## ORIGINATION FORM

### Proposed Revisions to a Standard Plans Index (Please provide all information — Incomplete forms will be returned)

Index Number: 653-001  
Sheet Number (s): 1  
Index Title: Pedestrian Control Signal Installation Details

PEDESTAL MOUNTED SIGNAL

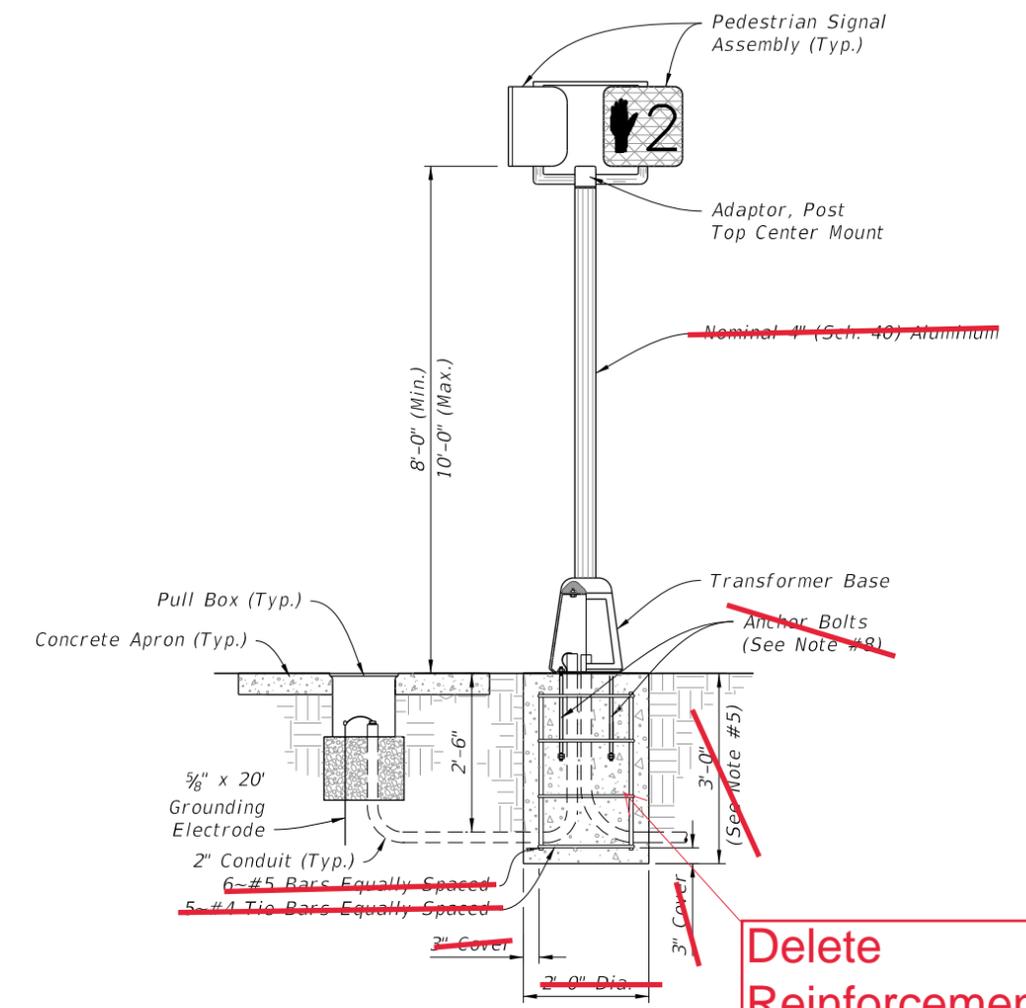
Pedestal Assembly details moved to new Index 646-001

5. For Pedestal Mounted Signal posts and foundations see Index 646-001

Move Existing Notes 5, 8, & 9 to New Index 646-001

Deleted specific details for the foundation and post of a Pedestal Mounded Pedestrian Signal. The details are moved to a new Standard Plans, Index 646-001.

The Pedestal Mounted Signal support (i.e., post, transformer base, and foundation) are controlled by Specification 646. Therefore, to clarify the requirements of the support details, and which Specification governs the installation and payment, the information is being moved to a new Index 646-001.

LAST REVISION 11/01/20	REVISION	DESCRIPTION:	 FY 2021-22 STANDARD PLANS	PEDESTRIAN CONTROL SIGNAL INSTALLATION DETAILS	INDEX 653-001	SHEET 1 of 1
---------------------------	----------	--------------	---	---	------------------	-----------------

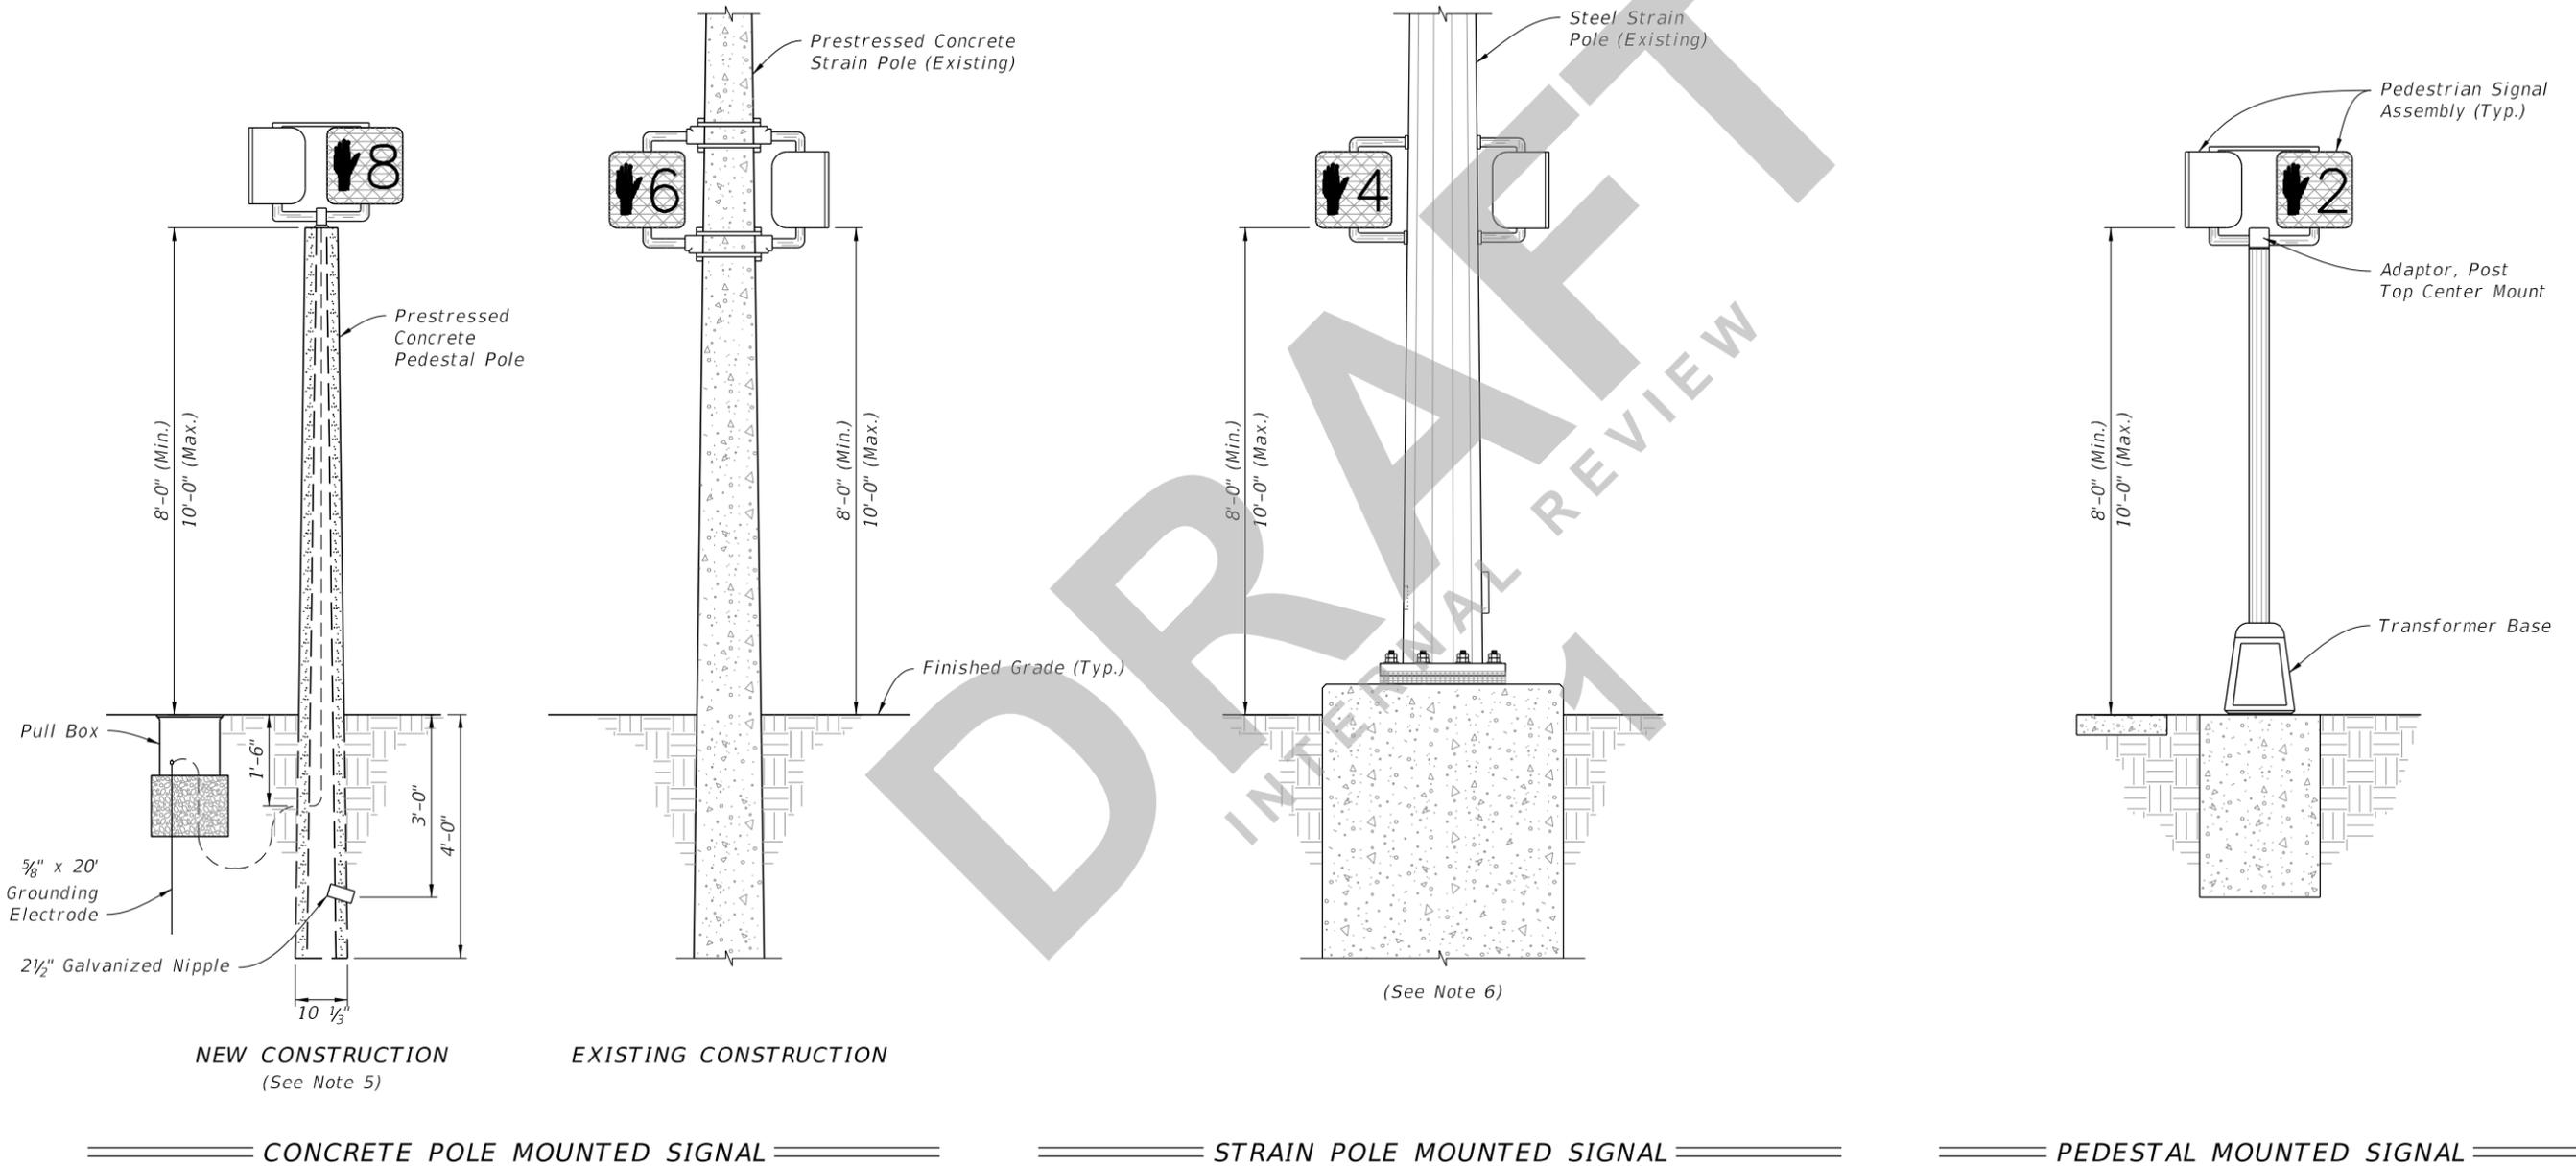
1. As an option, pedestrian signals may be installed on concrete poles and pedestals using lead anchors (two bolts same size per hub) in lieu of the stainless steel bands.
2. Repair drilled or punched holes in galvanized steel poles or pedestals in accordance with Specification 562. Install grommets or bushings in each hole.
3. Meet grounding requirements of Specification 620.
4. See APL for Department-approved Pedestrian Signal Assemblies and hardware.
5. For Steel Strain Poles see Index 649-010.
6. For Prestressed Concrete Poles see Index 641-010.
